Change Notice

AT4181

Change of Material of Rubber O-ring

AT4181P

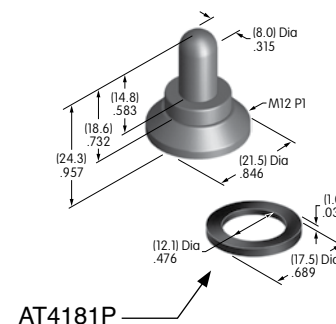
The material of the rubber o-ring (AT4181P) in the Splashproof Boot will change.

Material of Rubber O-ring	
Before Change	After Change
Natural rubber	NBR
